CROSS SECTIONS

REVISED NDC02	STATE VA.	ROUTE 621	STATE PROJECT 6234-076-266, C-501, RW-201	SHEET NO. X178
------------------	--------------	--------------	--	-------------------

Ramp 1A

REVISED NDC02	STATE VA.	ROUTE 621	STATE PROJECT 6234-076-266, C-501, RW-201	SHEET NO. X231
------------------	--------------	--------------	--	-------------------

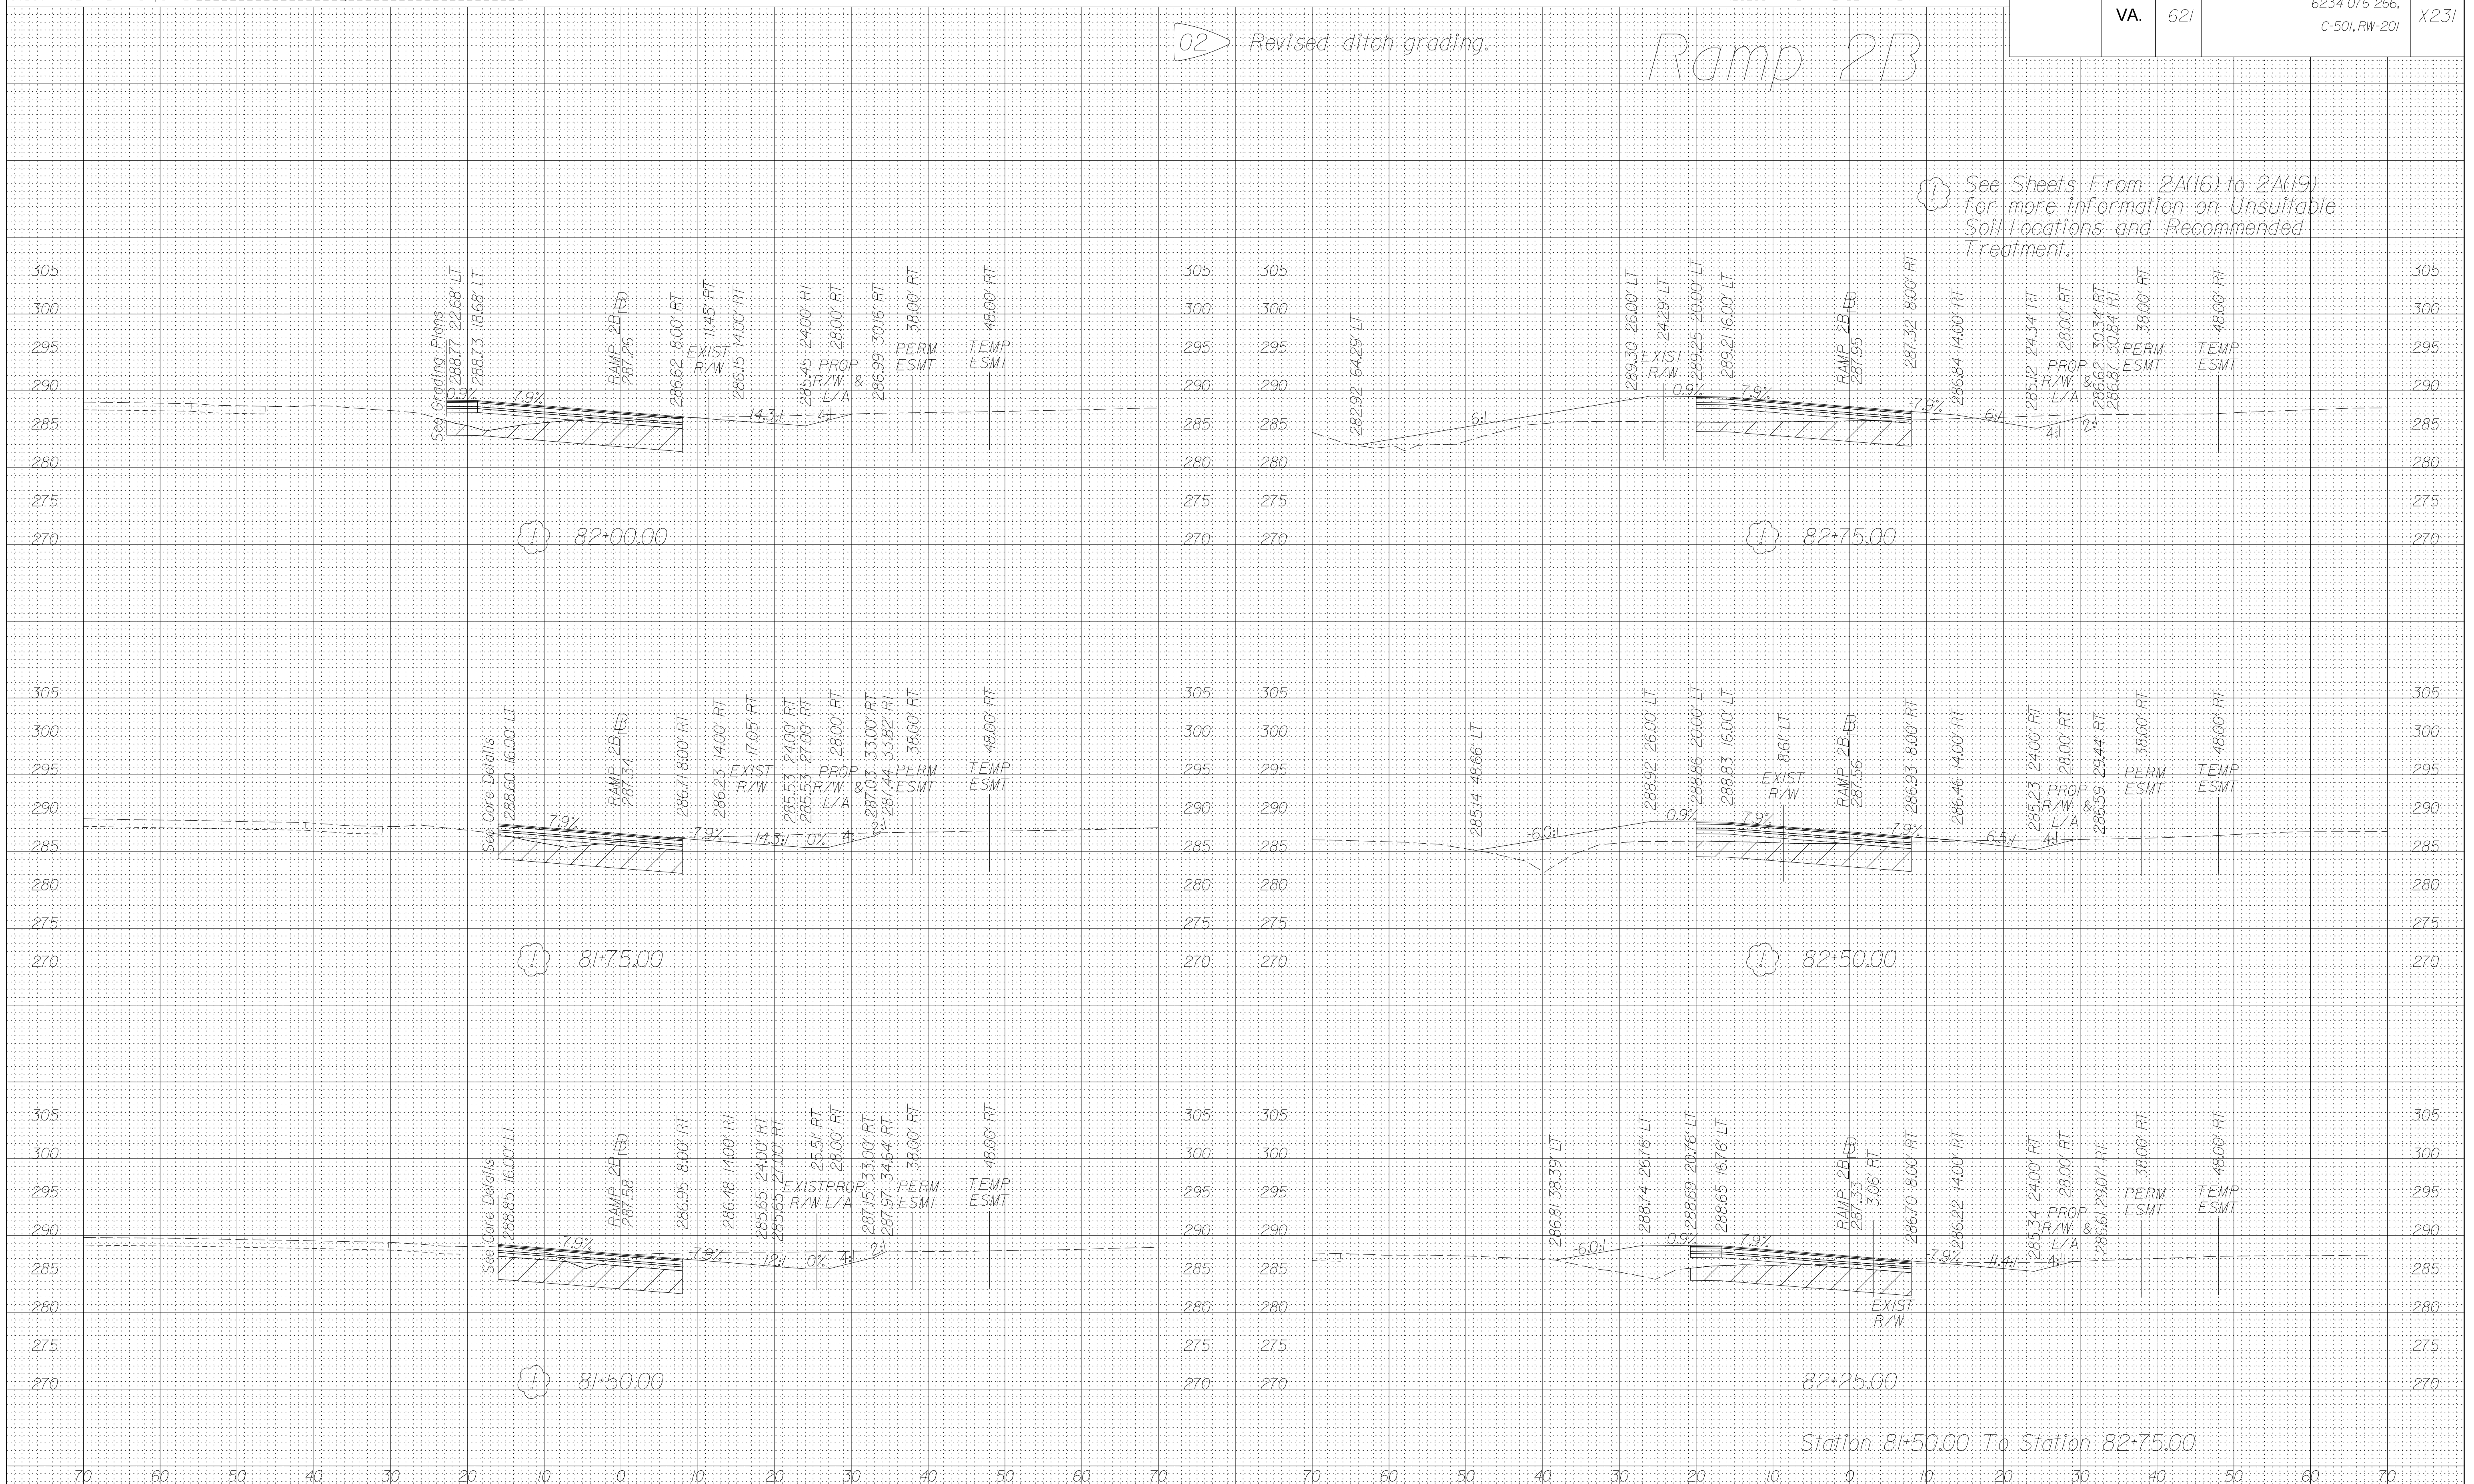
02 Revised ditch grading.

REVISED NDC02	STATE VA.	ROUTE 621	STATE PROJECT 6234-076-266, C-501, RW-201	SHEET NO. X232
------------------	--------------	--------------	--	-------------------

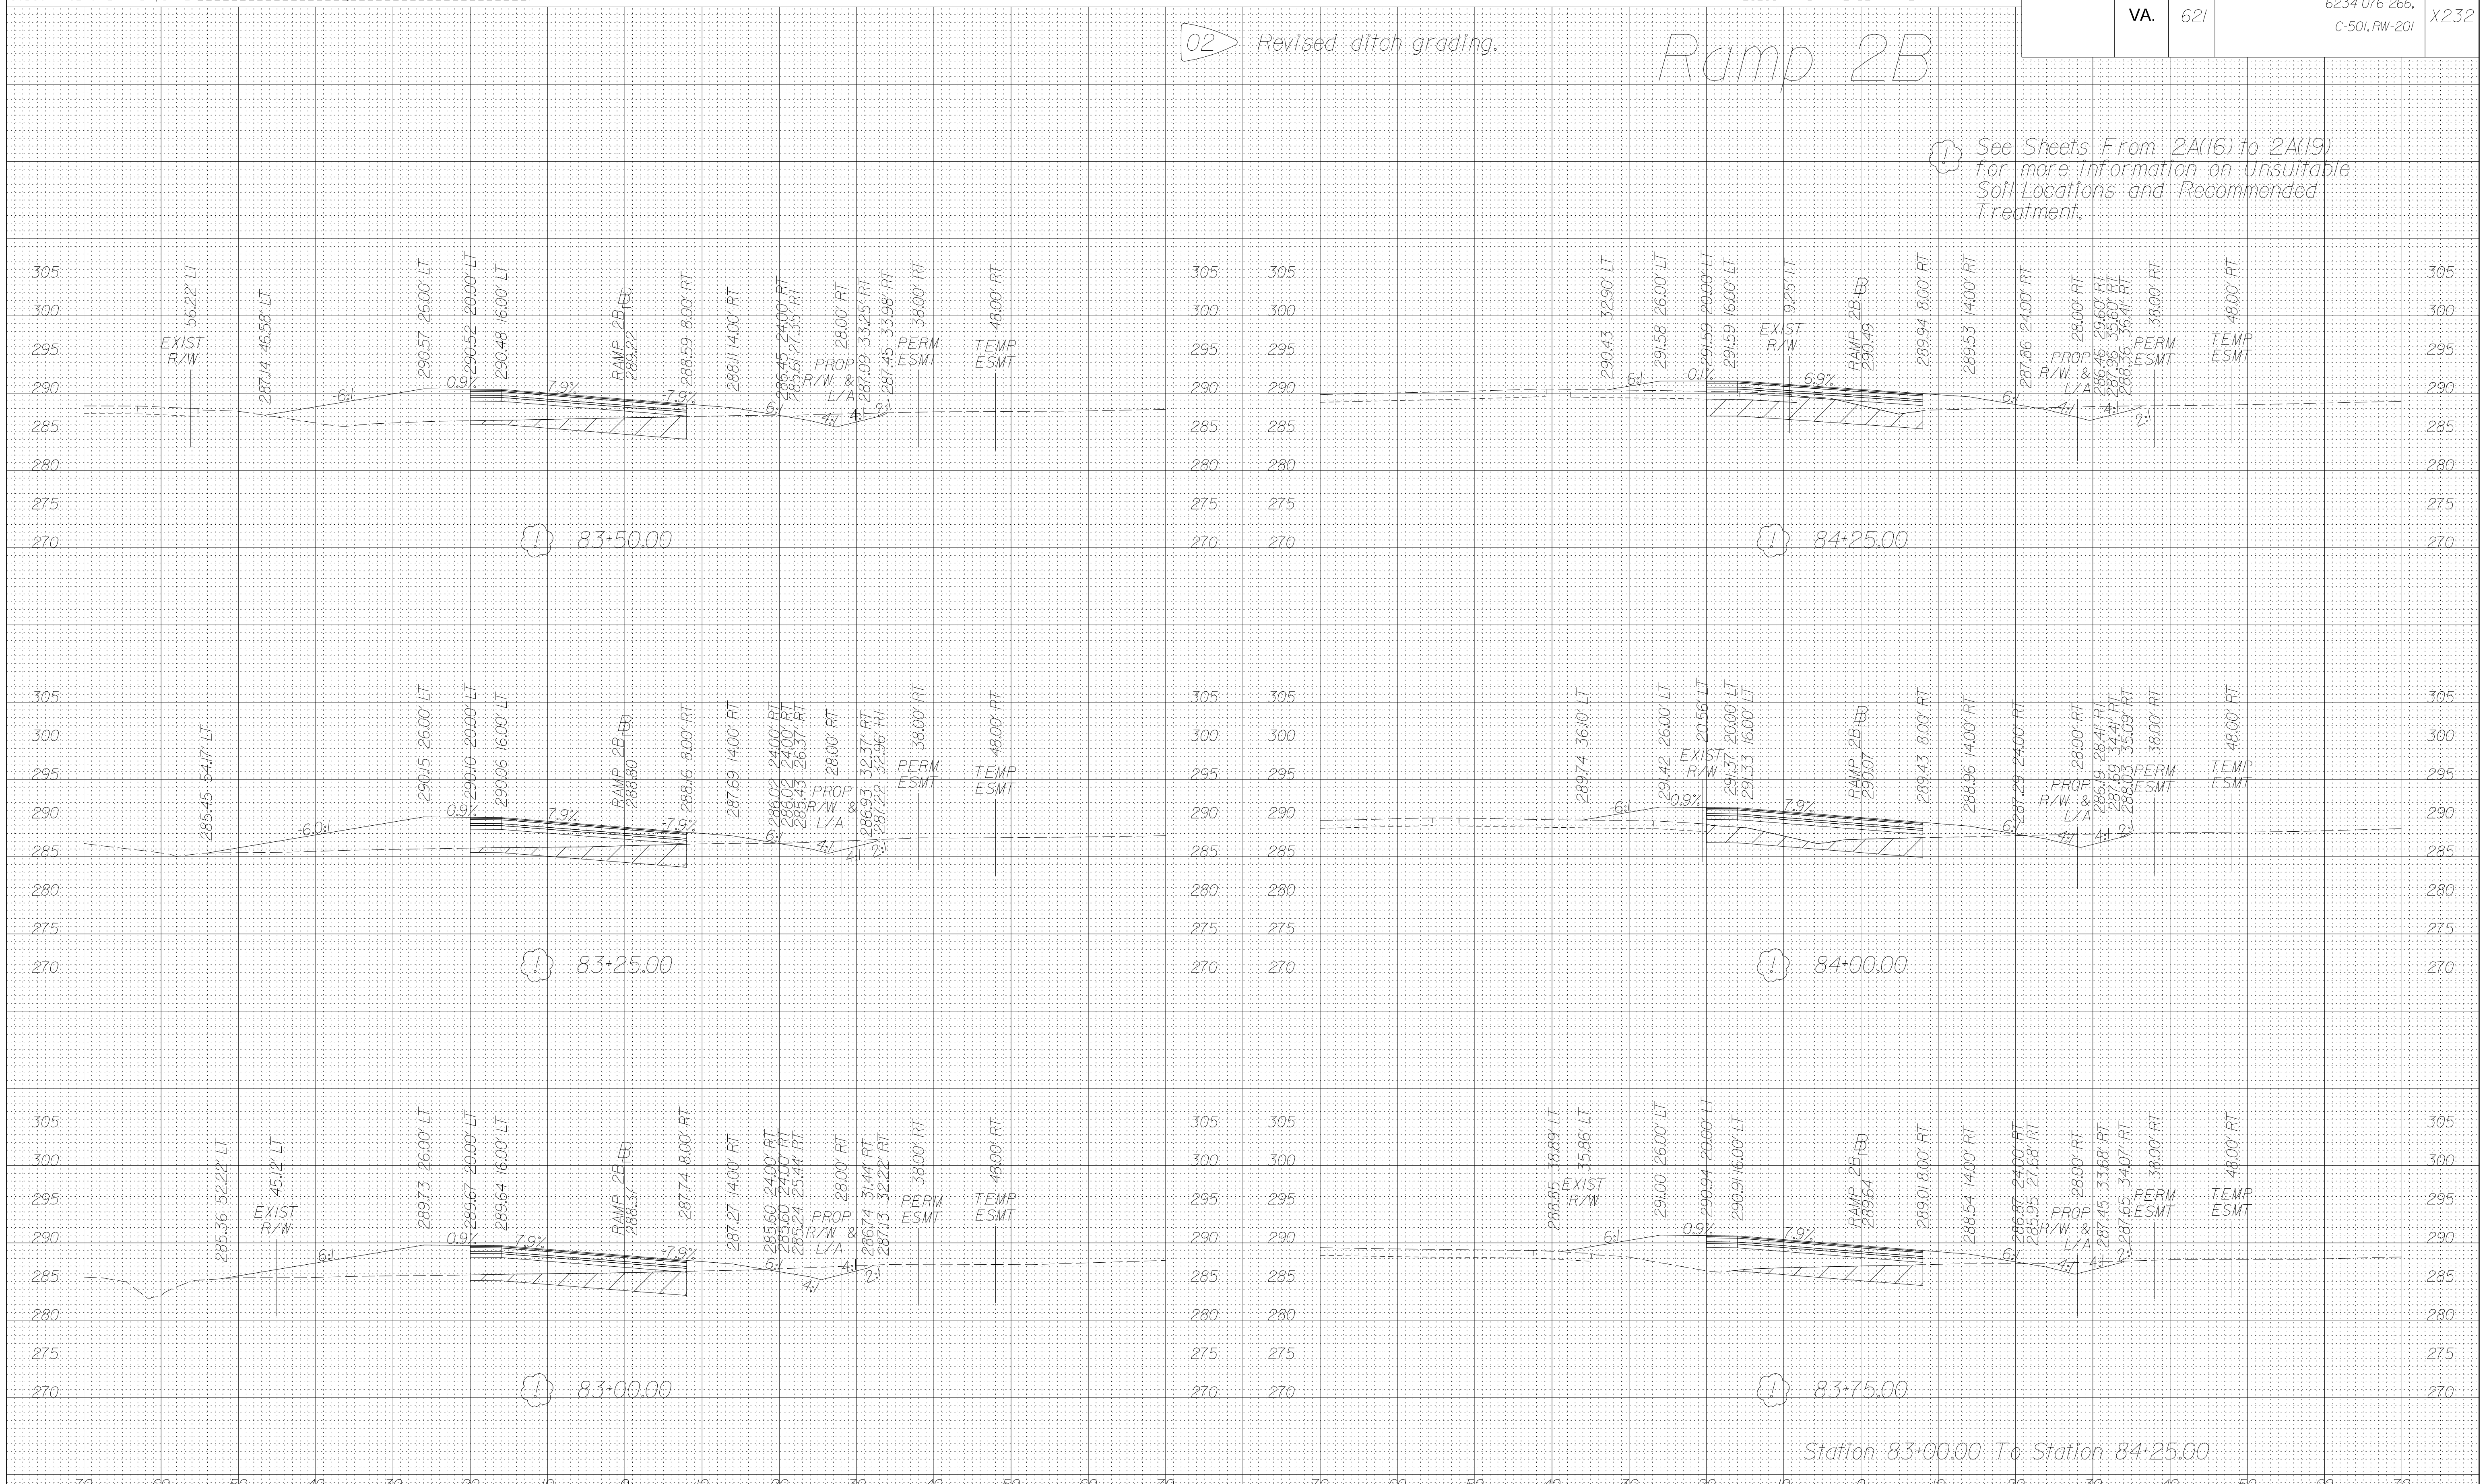
02 Revised ditch grading.

REVISED NDC02	STATE VA.	ROUTE 621	STATE PROJECT 6234-076-266, C-501, RW-201	SHEET NO. X234
------------------	--------------	--------------	--	-------------------

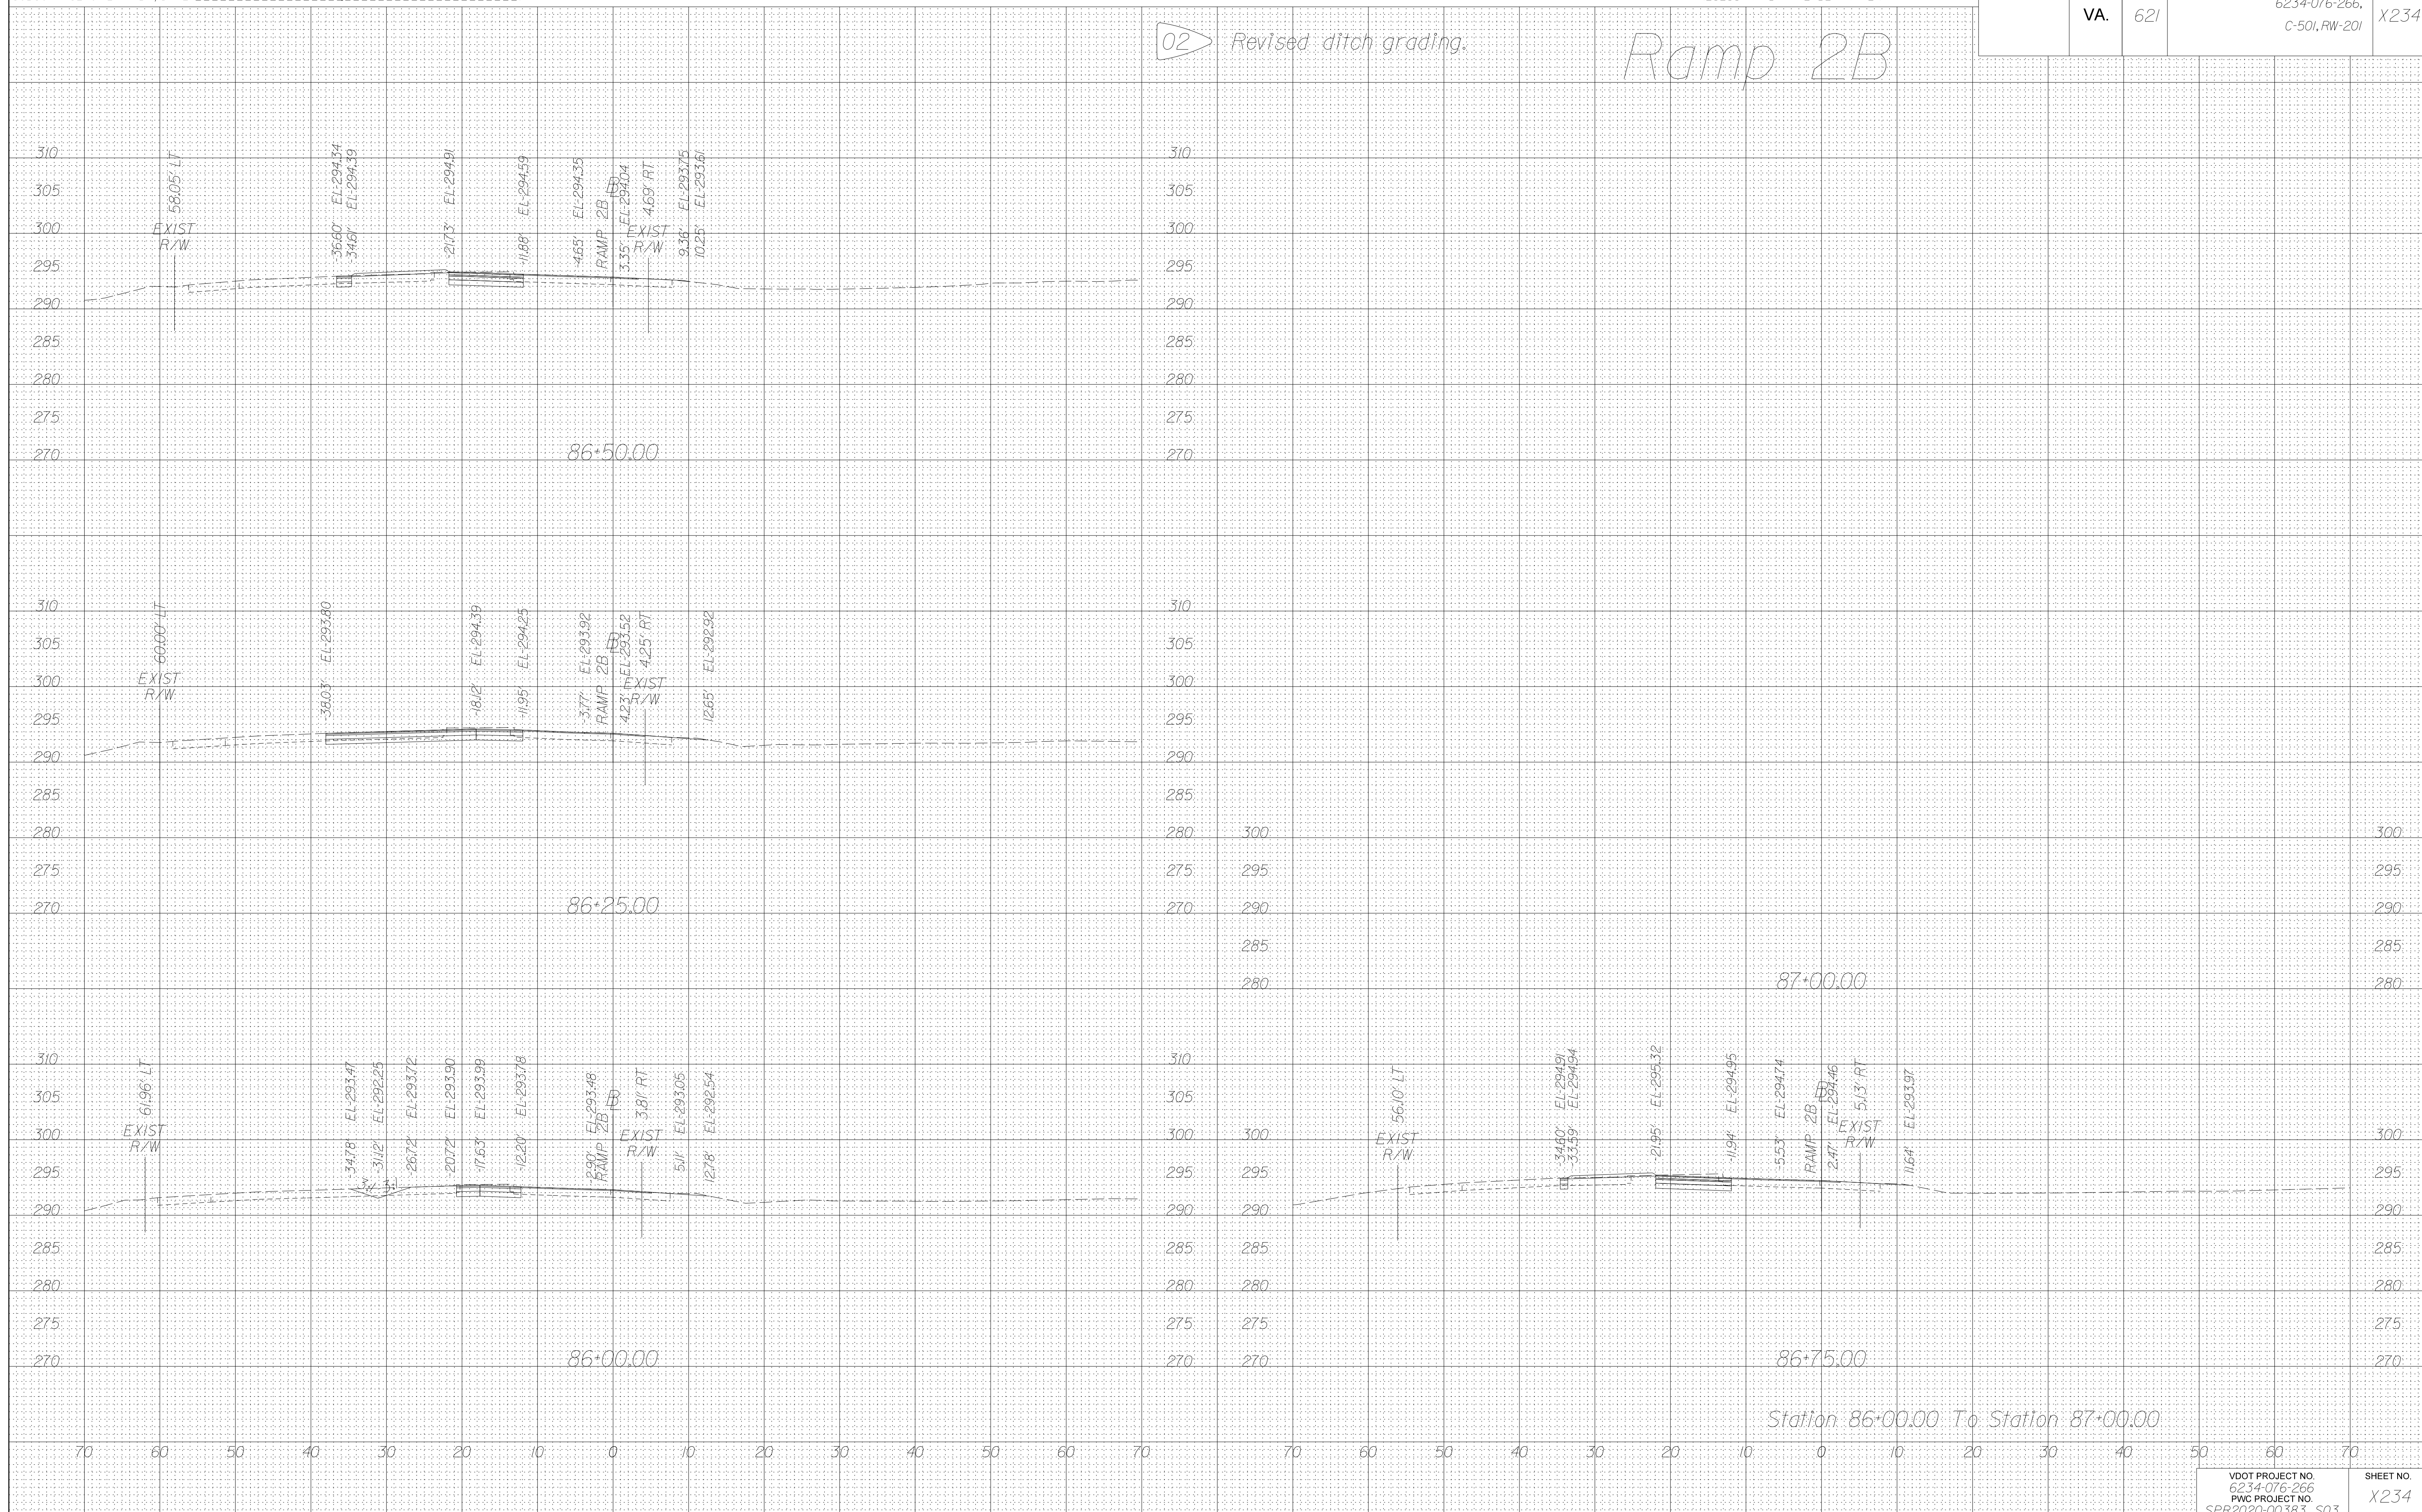
02 Revised ditch grading.
